From: Hilary Saunders
Sent: 02 June 2016 11:27
To: Planning
Subject: Fwd: Planning and Listed Building Applications at Browside Farmhouse, Browside, Ravenscar
Attachments: Riverside Fawthrop revised elev'ns.pdf

Project : Alterations to include addition of dormers to rear roof slope
 Location : Browside Farm, Stoupe Brow, Ravenscar
 Clients : Mr A Alderson & Mr S Fawthrop
 Title : Proposed house elevations

Drawing No: 293/4A

rear (north) elevation

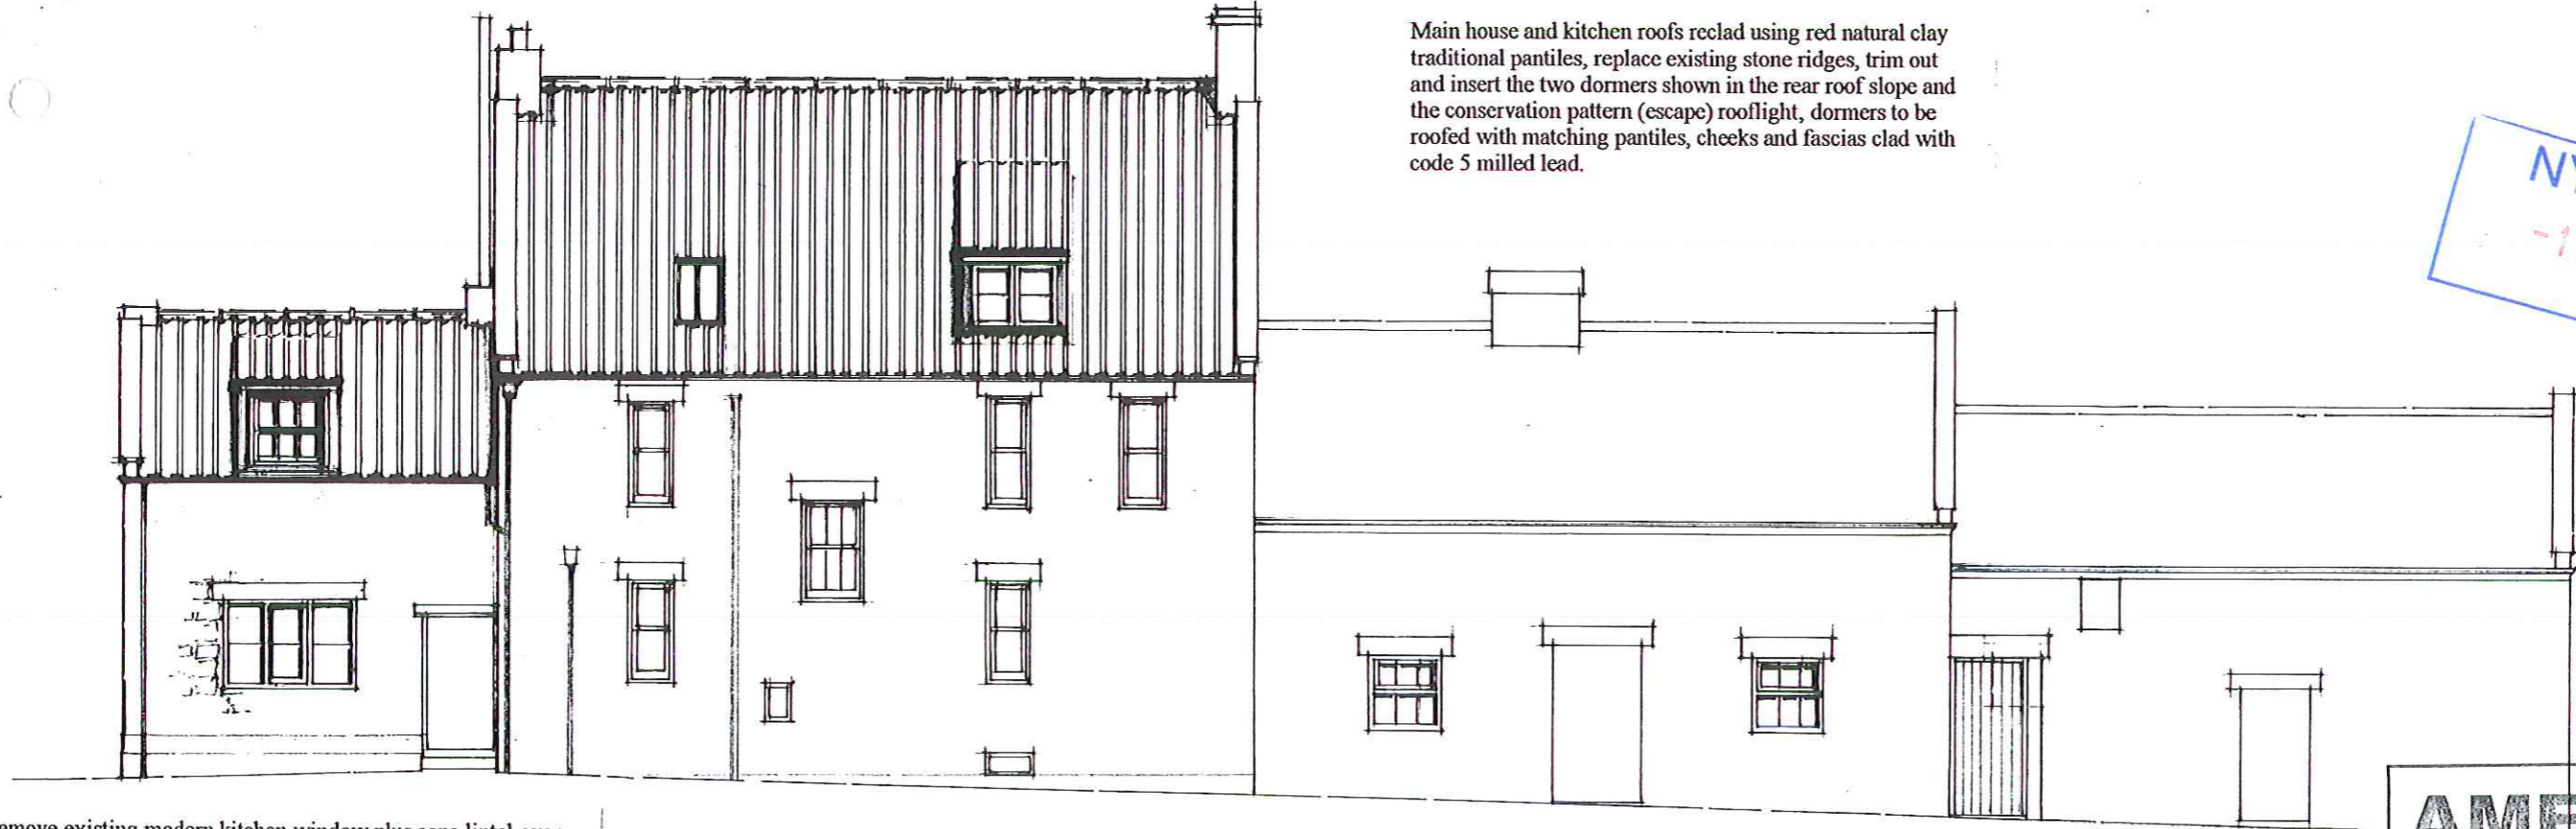
Hello Hilary, not sure if you are in the office this week but I've revised the dormer window above the above the kitchen as discussed and I'm attaching the drawing to this for you to view and down load..

I've now had the opportunity to discuss with Beth who has advised that the taller, slimmer 'hayloft' style of dormer is very agricultural and as the proposed dormer is in a clearly domestic part of the house, it should be the smaller dormer suggested. However, you may need to try and negotiate an agreement with Building Control.

As you may know, from the early drawings, I originally had a narrow dormer here in the 'hay loft door' style to hint at the door you've referred to but Beth asked me to change it to a/the smaller dormer with a sliding sash type window which you now see...

She also had mentioned sitting it at eaves level but as this will also be an 'escape window' in B Reg terms I felt that in doing as you've asked would make the bottom of the window too high above the floor level and thus difficult to get out of in an emergency..

I can make the change but am nervous for this reason.. What do you think?

Rear A - Dormer over kitchen raised

Main house and kitchen roofs re-clad using red natural clay traditional pantiles, replace existing stone ridges, trim out and insert the two dormers shown in the rear roof slope and the conservation pattern (escape) rooflight, dormers to be roofed with matching pantiles, cheeks and fascias clad with code 5 milled lead.

Remove existing modern kitchen window plus conc lintel over, enlarge opening as shown and build in new stone lintel over new Yorkshire light pattern window.
